**CITY OF BATON ROUGE
PARISH OF EAST BATON ROUGE**

ADDENDUM NO. 1

**SUBJECT: PEACHTREE STREET
DRAINAGE RENOVATIONS
CITY PARISH PROJECT NO. 20-CS-HC-0018**

TRENCH EXCAVATION & FINAL ASPHALT CONCRETE PAVEMENT REPLACEMENT DETAILS

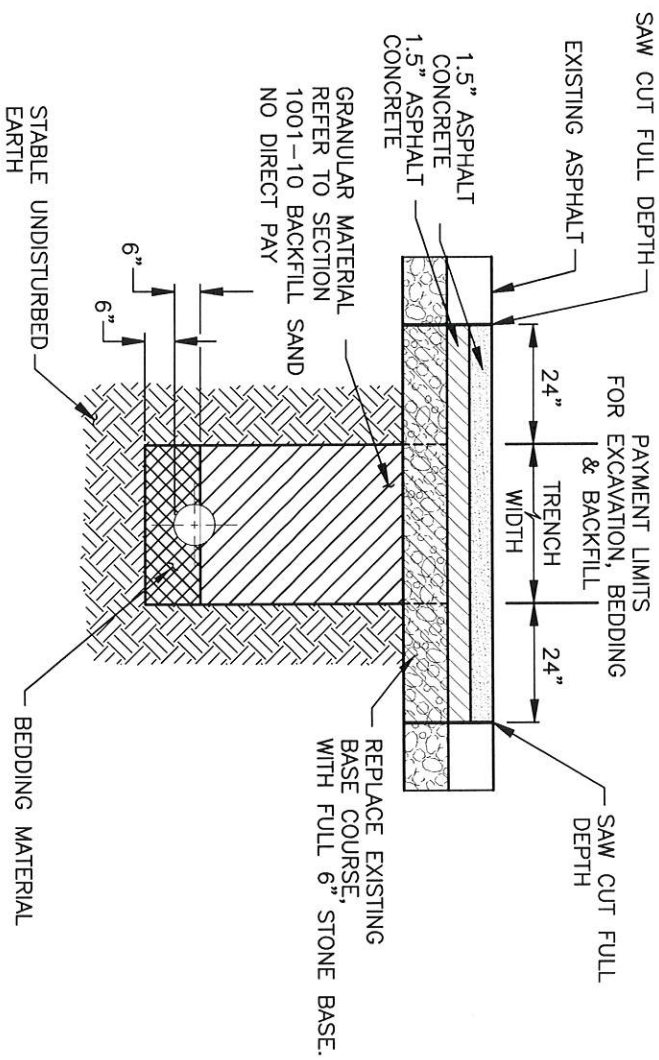
EXHIBIT

TRENCH EXCAVATION & FINAL ASPHALT CONCRETE (A.C.) PAVEMENT REPLACEMENT DETAILS is added.

WATER SHALL NOT BE PERMITTED IN TRENCH DURING CONSTRUCTION.
DEWATER AS NECESSARY.

GEOTEXTILE FABRIC SHALL BE OVERLAPPED 8" MINIMUM, NO DIRECT PAY.

ASPHALTIC CONCRETE PAVEMENT SHALL BE REPLACED WITH FULL DEPTH ASPHALT CONSISTING OF A 6" THICKNESS OF STONE BASE COURSE, 1.5" THICKNESS OF WEARING COURSE AND 1.5" THICKNESS OF BINDER COURSE.

ASPHALT CONCRETE PAVEMENT REMOVED IN EXCESS OF LIMITS SHOWN SHALL BE REPLACED BY THE CONTRACTOR AT NO ADDITIONAL COST TO THE OWNER.

BEDDING AND BACKFILL NEEDED IN EXCESS OF LIMITS SHOWN SHALL BE PROVIDED BY THE CONTRACTOR AT NO ADDITIONAL COST TO THE OWNER.

MAXIMUM PAYMENT LENGTHS FOR REMOVAL AND RESTORATION OF SURFACES SHALL BE THE SAME AS FOR THE EXCAVATION, BEDDING AND BACKFILL.

FINAL EDGES ALONG PAVEMENT REMOVAL LIMITS SHALL BE STRAIGHT, CLEAN, SOLID, VERTICAL FACES FREE FROM LOOSE MATERIAL PRIOR TO PAVEMENT RESTORATION. SAWCUTTING AT LIMITS SHOWN SHALL BE PAID ONLY ONCE PER TRENCH PATCH. ANY ADDITIONAL SAWCUTS FOR THE CONVENIENCE OF THE CONTRACTOR SHALL BE AT NO ADDITIONAL COST TO THE OWNER.
